## RESPONSE TO REQUEST FOR ADDITIONAL INFORMATION

### APR1400 Design Certification

**RAI No.:** 506-8649  
**SRP Section:** 10.03.06 – Steam and Feedwater System Materials  
**Application Section:** 10.3.6  
**Date of RAI Issue:** 07/26/2016

### **Question No. 10.03.06-26**

Figure 3 Piping layout comparison of the OPR1000 and APR1400 designs

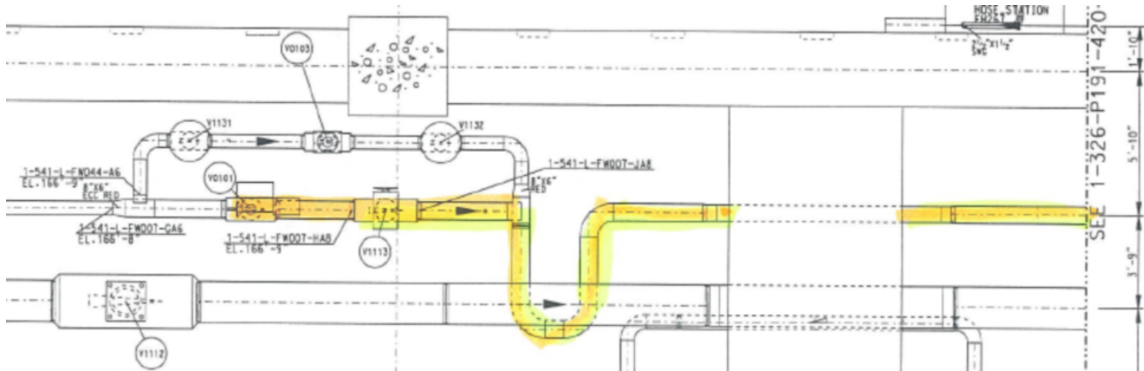
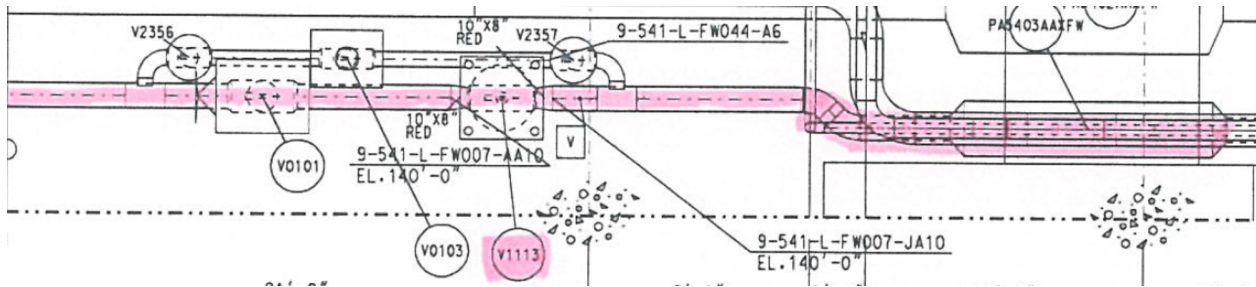
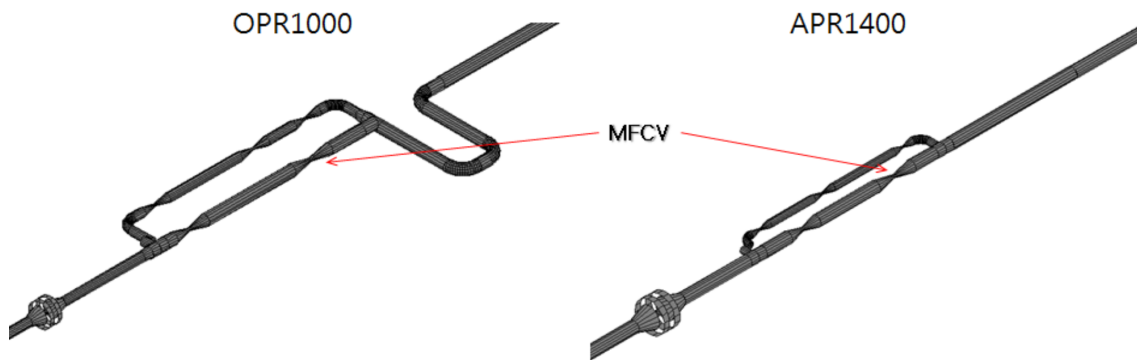
During the audit on May 10, 2016, the staff reviewed design documents for the feedwater system. While reviewing the design documents, the staff noted that a portion of downcommer feedwater line downstream of the downcommer flow control valve has a configuration of chrome-moly steel . carbon steel . chrome-moly steel. This configuration was not apparent to the staff prior to the audit.

DCD Tier 2, FSAR Table 10.3.2-4 lists material specifications for components in the feedwater system. This table does not have an entry for the carbon steel portion of the line between the chrome-moly portions of the downcommer feedwater line. The material specifications were not found in DCD Tier 2, FSAR Chapter 10 or Chapter 6. The carbon steel portion of the line contains the safetyrelated Main Feedwater Isolation Valves.

- a. What material specifications are utilized for the carbon steel portion of the downcommer feedwater line between the chrome-moly portions of the same line (including the Main Feedwater Isolation Valves and connected safety-related piping)? This information should be added to DCD Tier 2, FSAR Chapter 10 or 6.
- b. Are the carbon steel portions of the downcommer feedwater line between the chrome-moly steel portions subject to augmented in-service inspection (ISI)? If augmented ISI will be performed on this section of piping, DCD Tier 2, FSAR Section 6.6 should be updated to state that these components are subject to augmented ISI and the augmented ISI should be described. If augmented ISI will not be performed, provide a justification on why additional ISI is not necessary considering that there may be an active degradation mechanism (FAC).

- a. In the OPR1000 design, chrome-moly steel is utilized between the MFCV and MSVH line, which contain sharp bending portions susceptible to FAC as shown in Figure 1. In the APR1400 design, carbon steel is utilized between the MFCV and MSVH line, which do not have sharp bending portions as shown in Figure 2. A 3D piping layout is presented in Figure 3 between the MFCV and MSVH line comparing the OPR1000 and APR1400 designs. Accordingly Table 10.3.2-4 will be revised.
